MODIFICATION REQUEST:

***Discovery Point Concept Plan Modification 1
MP 10_0003 MOD 1***

Discovery Point, 1 Princes Highway, Wollongong

***Modification of solar access to Building 6 and
modification of building separation between
Building 2 and adjoining building.***

Figure 4: Impact on Building 11 from complying with 60% solar access requirement (Source: Proponent's Report)

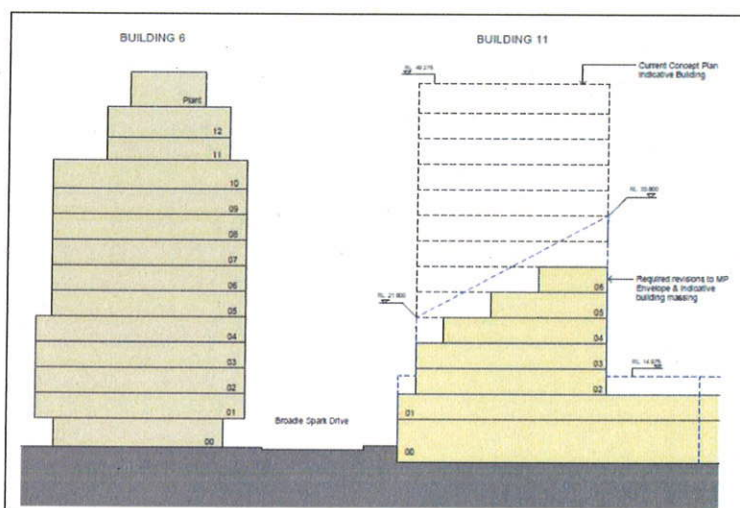
The extent of the reduction in the height of Buildings 7 and 11 necessary to ensure solar access to 60% of units in Building 6 is demonstrated in Figures 4 and 5 below. Such a reduction would significantly reduce the number of dwellings able to be provided on the site. It would also have the potential to result in a less harmonious appearance of the development, as the approved envelopes were designed in conjunction with surrounding built forms to ensure a congruent overall urban design outcome. There would also be a reduction in the solar access performance for Buildings 7 and 11 as there would be significantly less apartments left within those buildings that would be able to achieve solar access targets. Therefore on balance, any improvement to solar access to Building 6 is outweighed by the detrimental impacts which arise from the necessary change to Buildings 7 and 11.

On this basis the proposed modification to delete the numerical requirement for solar access to Building 6 within the Development Design Guidelines is supported.

Figure 7: Extract from proposed amended Building Envelopes Plan

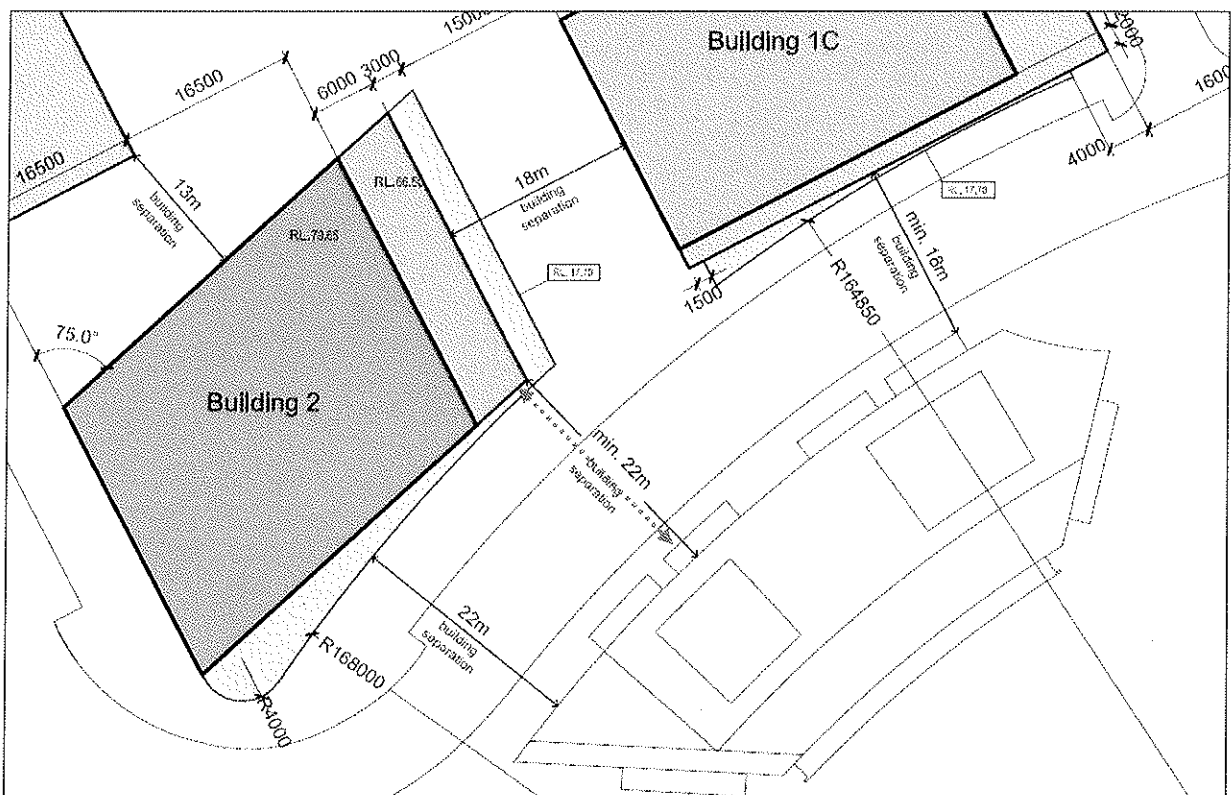
The modified plan also seeks to correct a drafting error on the Building Envelopes Plan regarding to the separation distance between proposed Building 2 and the existing building "Verge" to the south. The approved plan shows a 22m separation distance between the upper northern section of Building 2 to the edge of the balconies on the Verge building. The proponent advises it was intended that the arrow should instead point to the façade of the Verge building.

This dimension was not given any particular consideration in the assessment of the Concept Plan application. However applying the dimension to the façade, rather than to the balcony edge is more consistent with the scaling on the approved building envelopes plan and therefore appears to support the proponent's assertion that it was a drafting error.

The RFDC rule of thumb requires a building separation of 18 metres for 5-8 storeys in height and a separation of 24 metres for the 9th storey and above. As the Verge building only has balconies on the lower 8 floors, the separation distance from the proposed building to the balconies on the Verge will comply with RFDC regardless of the modification.

However the modification would result in a variation from the RFDC for floors 9 and above. The extent of this variation would be relatively minor: being no more than 2 metres at the northern most end of the building, increasing gradually so that the southern end of the façade fully complies with the 24m separation distance set by the RFDC.

The modification would also ensure that the northern end of Building 2 would be consistent with the setback between the Verge and the upper floors of adjoining Building 1C and therefore would result in a more consistent built form outcome.

On this basis the proposed modification is supported. Accordingly, Figure 18 of the Development Design Guidelines is also modified to be consistent with the new plan. Figure 23 showing various building separation distances is deleted as the figure is now out-dated and all relevant information is depicted on the approved building envelopes plan. The building separation controls (Section 5.6 of the Guidelines) are therefore amended to refer to Figure 18 rather than Figure 23.
